In regards to the Development Permit and Rezoning Application for 1568 East King Edward Avenue (formerly 1526-1560 Kingsway), which was approved at Public Hearing on October 22, 2013, the following records:

1568 E King Edward (formerly 1526-1560 Kingsway)
PUBLIC CONSULTATION SUMMARY - DRAFT

**Re: 1526 Kingsway DE416646, Vancouver, BC
 Responses to Prior-to Conditions**

Exhibit 1 Parkade Circulation

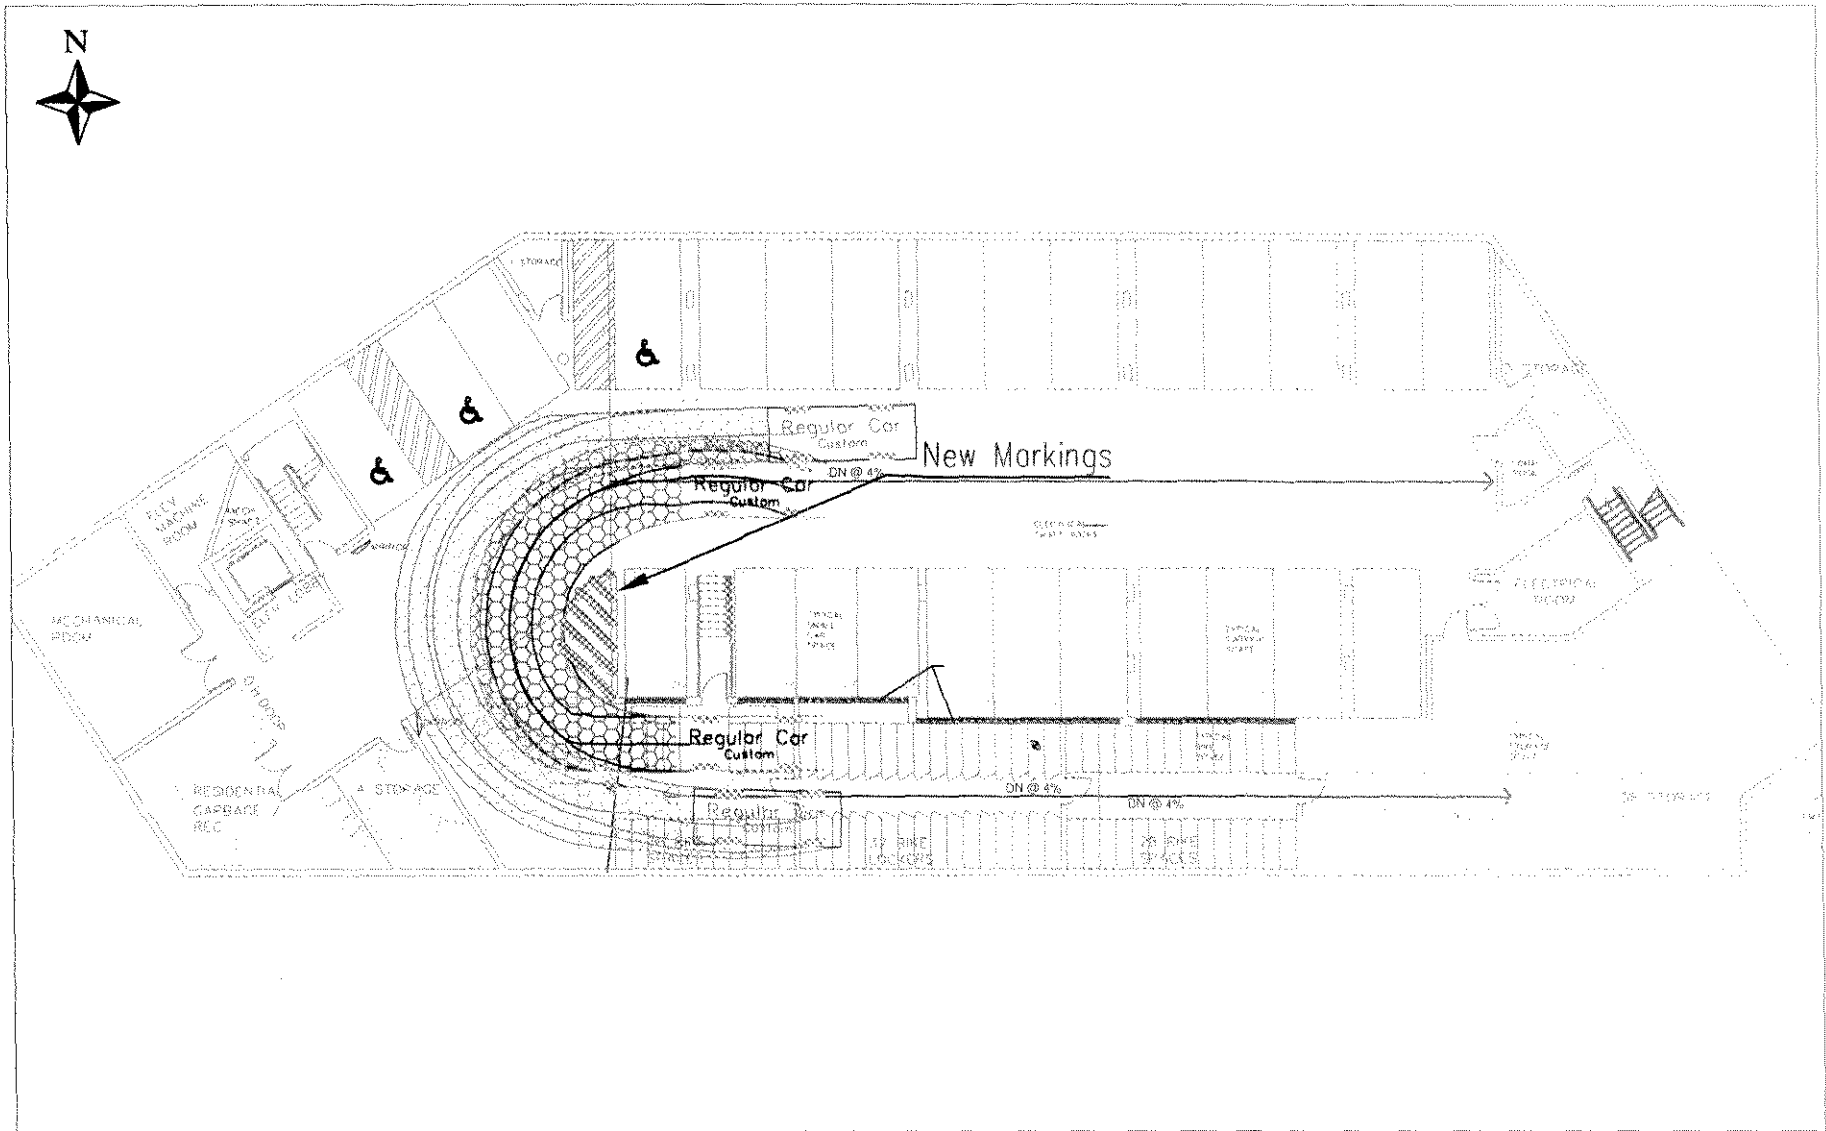
- *Provision of measures to improve visibility of inbound vehicles on the main parking ramps.*

(Note to Applicant: Vehicles at the bottom of the ramp will turn wide into the path of exiting cars, so visual identification of each vehicle is important.)

We have verified the anticipated vehicle turning paths using the AutoTURN computer program at the both ends of the parking ramp, as illustrated in attached **Exhibits 1 and 2**. We confirm there is adequate vehicle turning space available. To ensure visibilities, we propose to install traffic control devices, such as reflective mirrors, pavement markings, as illustrated in the exhibits.
